TITLE: A RESOLUTION AWARDING THE BID FOR A PRICING AGREEMENT FOR THE PURCHASE OF STREET LIGHTING POLES AND FIXTURES TO CONSOLIDATED ELECTRICAL DISTRIBUTORS (CED) OF LAS CRUCES, NM IN THE AMOUNT OF \$78,212.50, PLUS \$5,914.82, FOR NEW MEXICO GROSS RECEIPTS TAX FOR A TOTAL AUTHORIZATION IN THE AMOUNT OF \$84,127.32 FOR A PERIOD OF ONE YEAR WITH THE OPTION TO RENEW FOR TWO ADDITIONAL YEARS.

**ADDENDUM TWO**

BID NUMBER: 13-14-376**BID TITLE:** Street Light Poles and Accessories PA**DUE DATE/TIME:** January 27, 2014 / 2:00 p.m.

THE DAVIT POLES
CUSTOMER: CITY OF LAS CRUCES, NM
SCALE: J2 DATE: 10/07/87
BY: LW Dwg. No. 060030

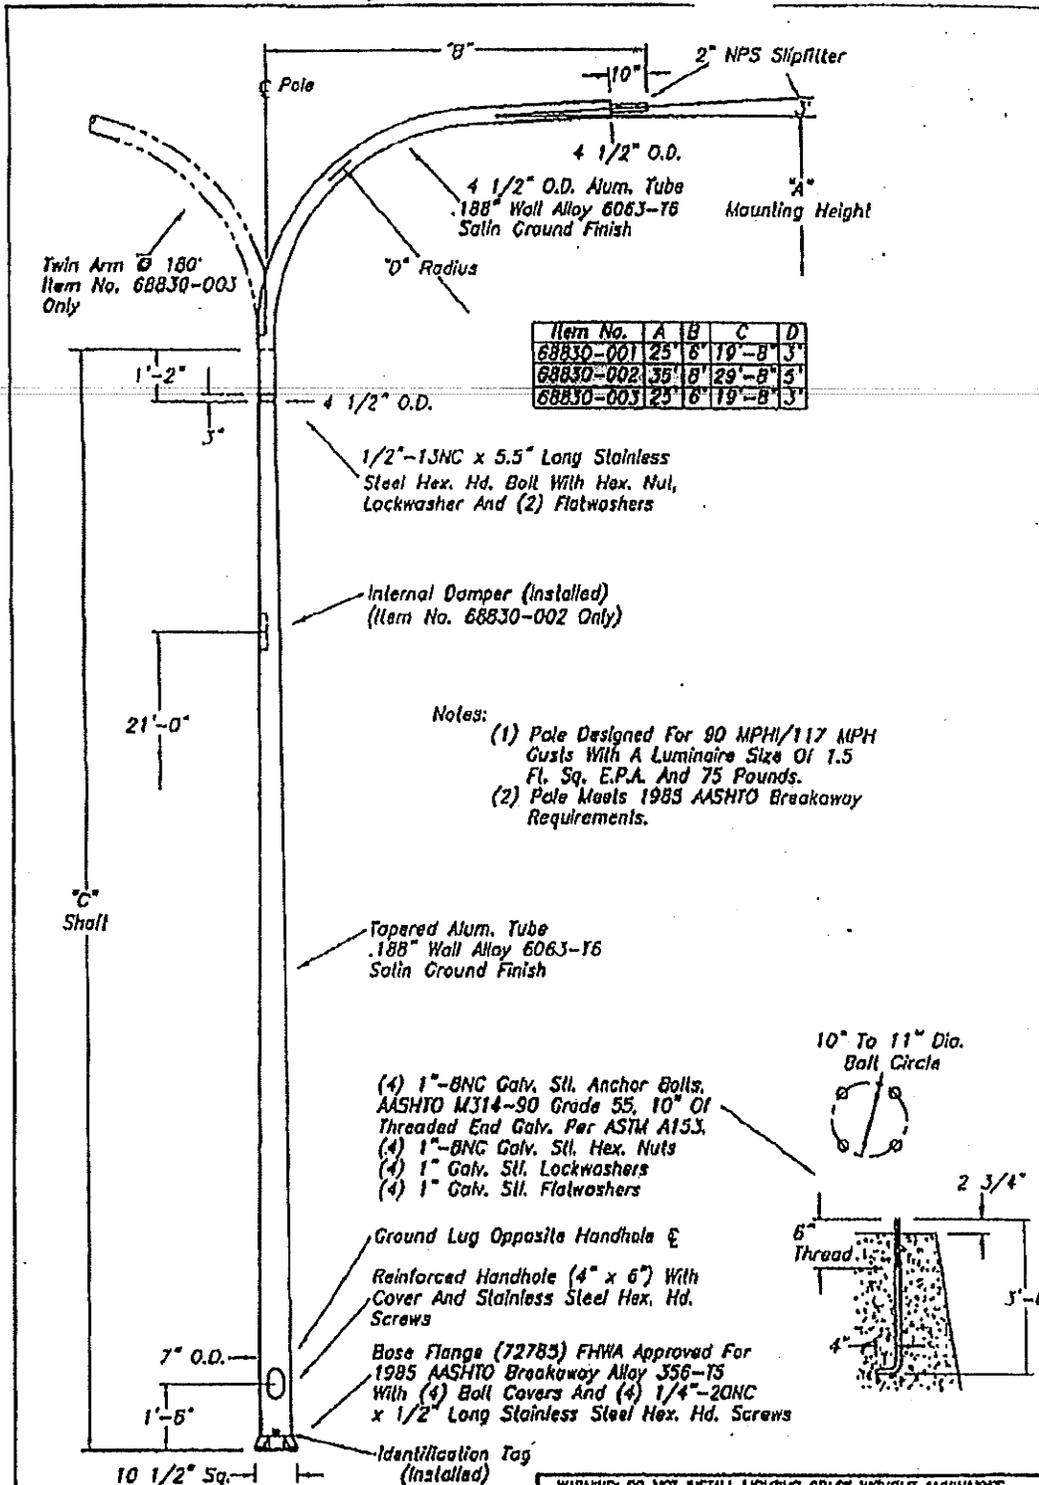
Q4: Item 2 refers to a 35' Hapco pole or equal with breakaway base. Is the PN listed for the base or pole and is this pole also a davit pole? Would a drawing be available? Sizing questions as shown above.

A4: The PN refers to the pole number proprietary to the City of Las Cruces from Hapco. The breakaway base does not have a number but must be AASHTO rated. See drawing on next page.
